Title - Sujet Construction Services	
Solicitation No. - N° de l'invitation EZ899-152249/A	Amendment No. - N° modif. 006
Client Reference No. - N° de référence du client	Date 2015-04-22
GETS Reference No. - N° de référence de SEAG PW-\$PWY-019-7491	
File No. - N° de dossier PWY-4-37355 (019)	CCC No./N° CCC - FMS No./N° VME
Solicitation Closes - L'invitation prend fin at - à 02:00 PM on - le 2015-04-30	
F.O.B. - F.A.B. Plant-Usine: <input type="checkbox"/> Destination: <input checked="" type="checkbox"/> Other-Autre: <input type="checkbox"/>	
Address Enquiries to: - Adresser toutes questions à: Ngan, Ken (PWY)	Buyer Id - Id de l'acheteur pwy019
Telephone No. - N° de téléphone (604) 658-2755 ()	FAX No. - N° de FAX (604) 775-6633
Destination - of Goods, Services, and Construction: Destination - des biens, services et construction: CBSA - Pleasant Camp Port of Entry - Pleasant Camp, BC

Please find following Addendum No. 3.

Project No. R.0171363.001

Tender A – Pleasant Camp Port of Entry

Drawing title
RV PAD SITE PLAN AND DETAILS

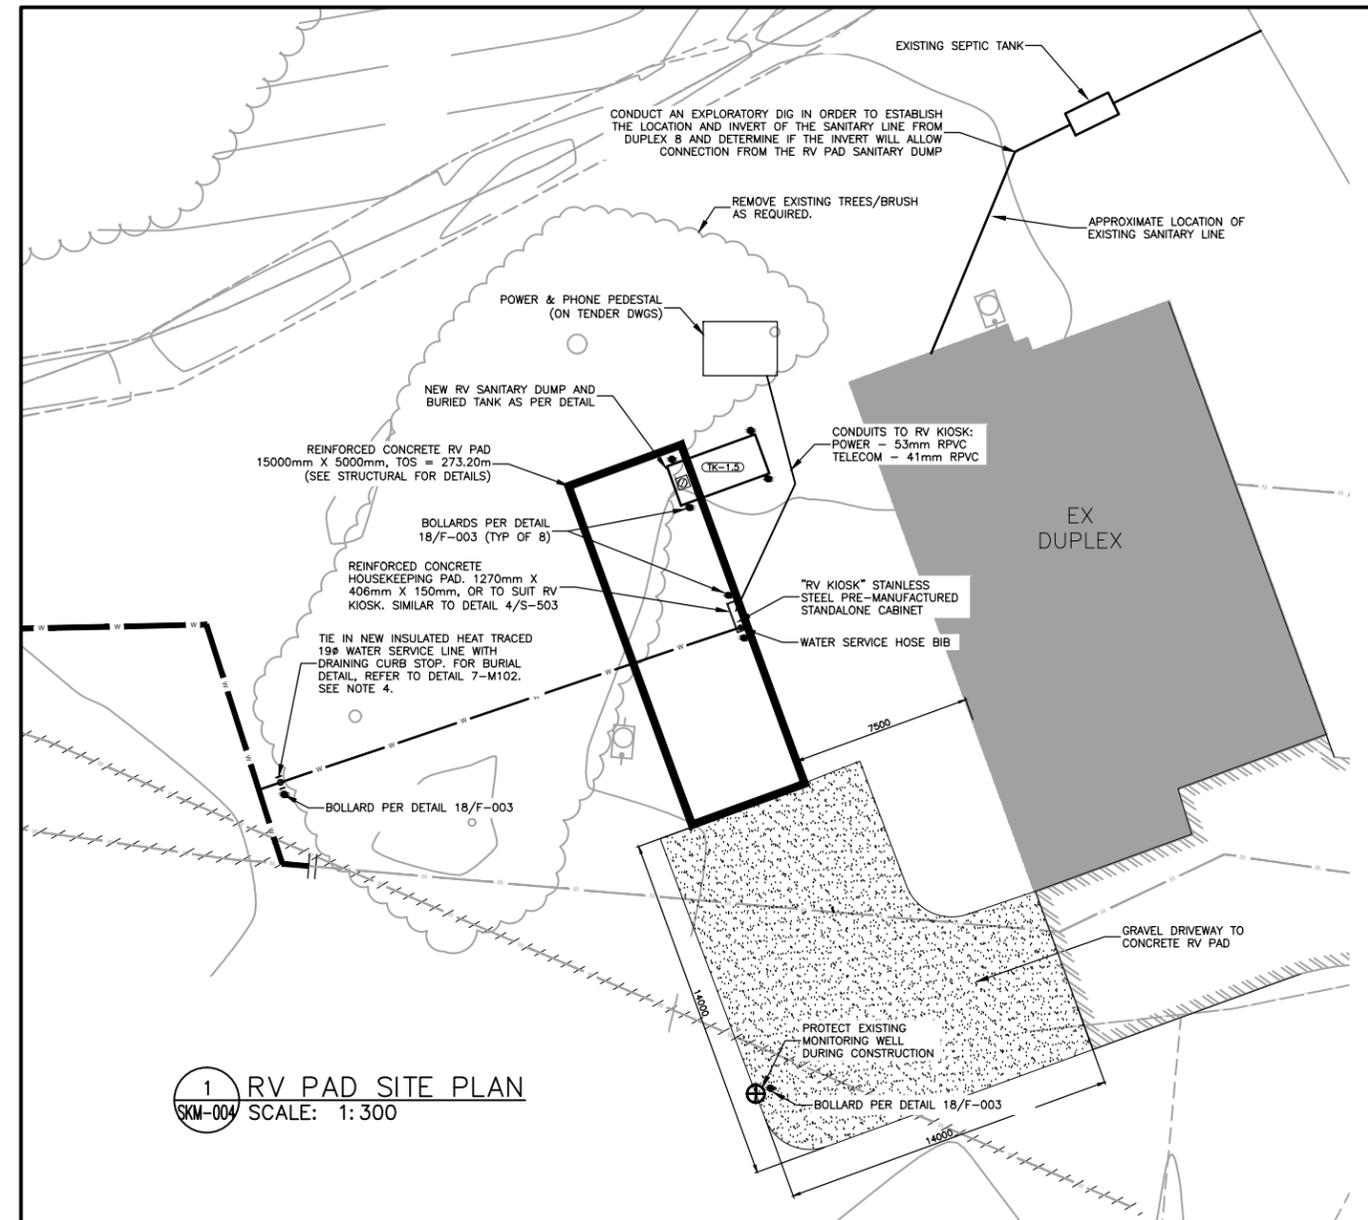
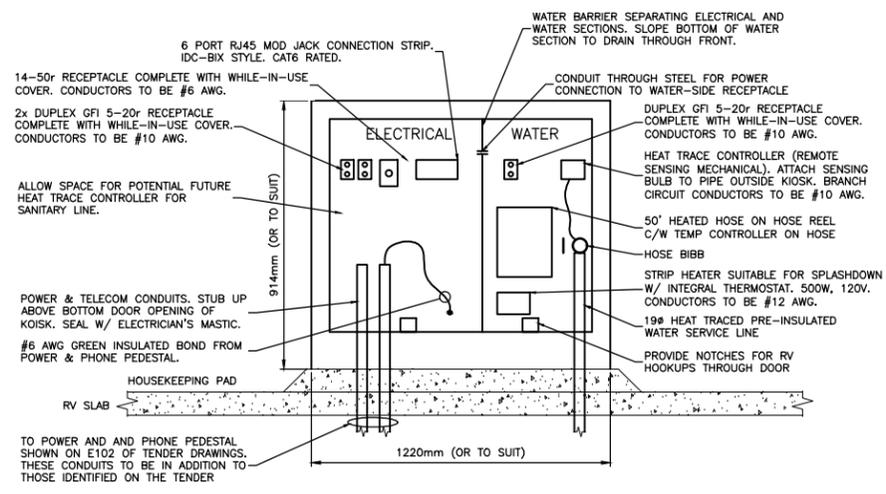
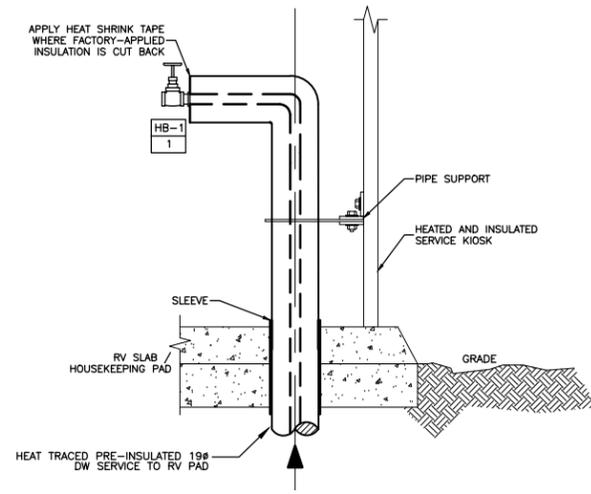
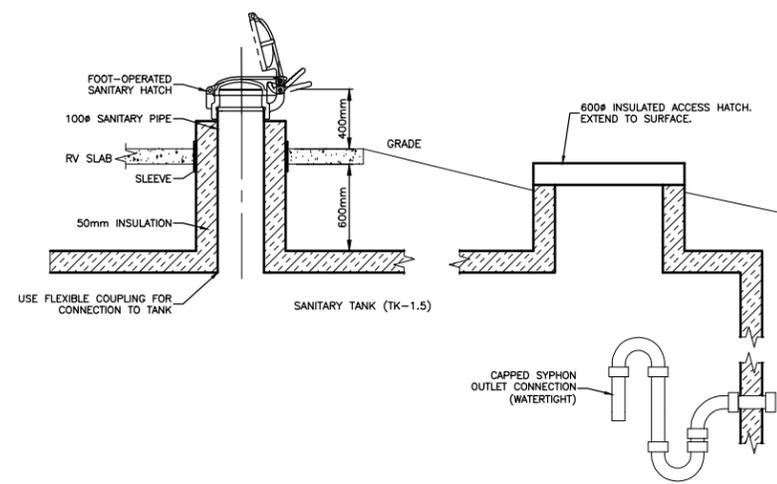
1. Drawing M002, plan 2 (South): add RV pad and services as shown on attached sketch SKM-004 including:
 - a. 19mm diameter insulated heat traced RV water service as specified in 22 11 13 Facility Water Distribution Piping

- b. Buried septic tank and RV dump as specified herein
 2. Drawing E301: Replace schedule for Panel B with the attached as shown on drawing SKE-401.
 3. Drawing E301: Referring to detail 4/E301, delete breaker in Panel A associated with P-1.1.

7. Add electrical services to proposed new RV Pad as described on attached drawing SKM-004.
 8. Provide power and control electrical services to the proposed new water treatment plant and associated accessories as described on attached drawing SKE-401.

SKETCH: SKM-05

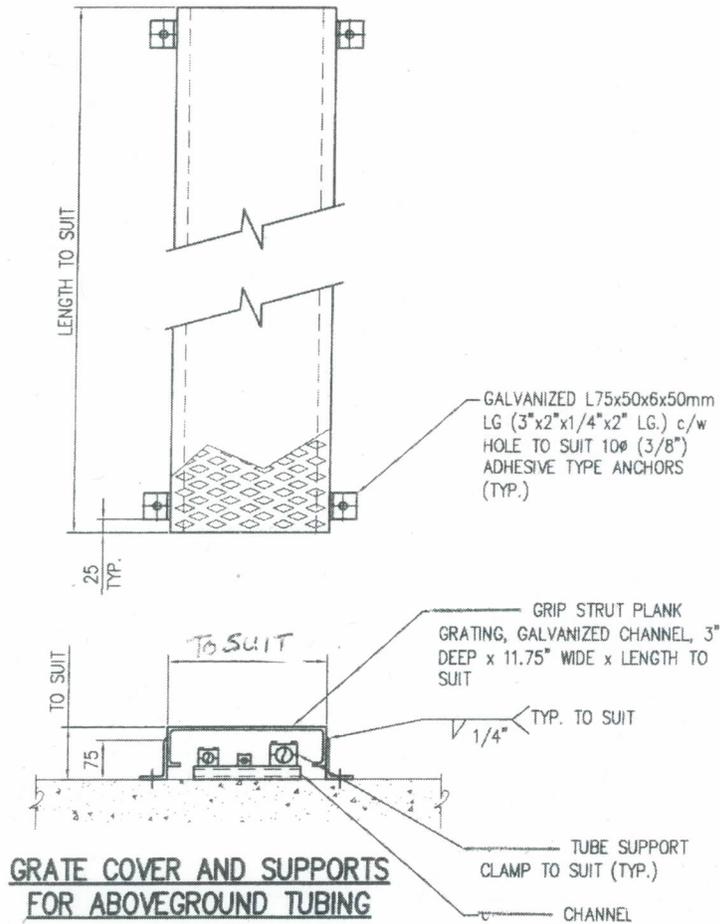
- The portion of the generator fuel supply and return tubing that runs along the floor shall be protected by an expanded metal galvanized steel grating cover with bolting tabs attached to provide clearance for the piping. See attached sketch SKM-005.

Drawing title
WATER TREATMENT PLANT ELECTRICAL

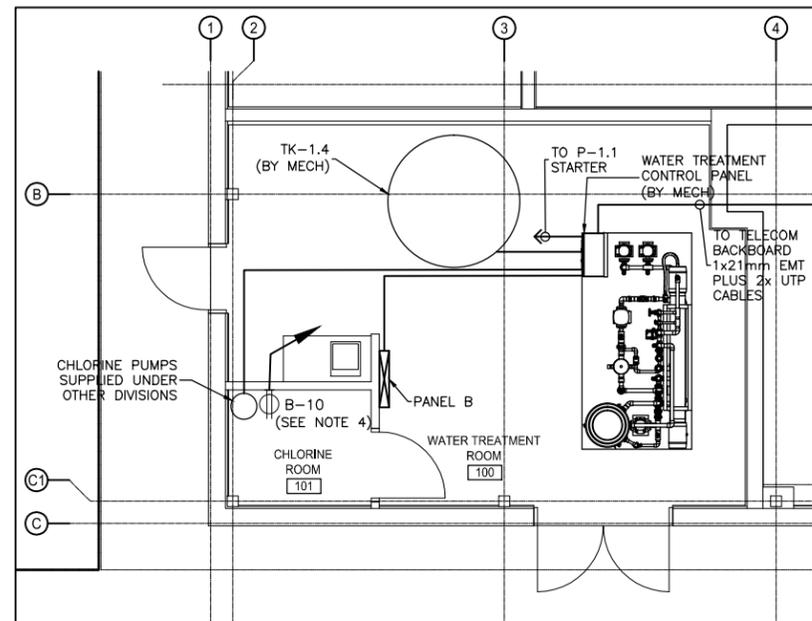
9. Panel K to be as described on attached SKE-401.
 10. Drawing S-001: Add following notes regarding Structural details for new RV pad
Slab on grade for RV:

- NOTES:
1. THIS SCHEDULE REPLACES THE PANEL B SCHEDULE ON DRAWING E301, REV 0, ISSUED FOR TENDER, 15/02/02
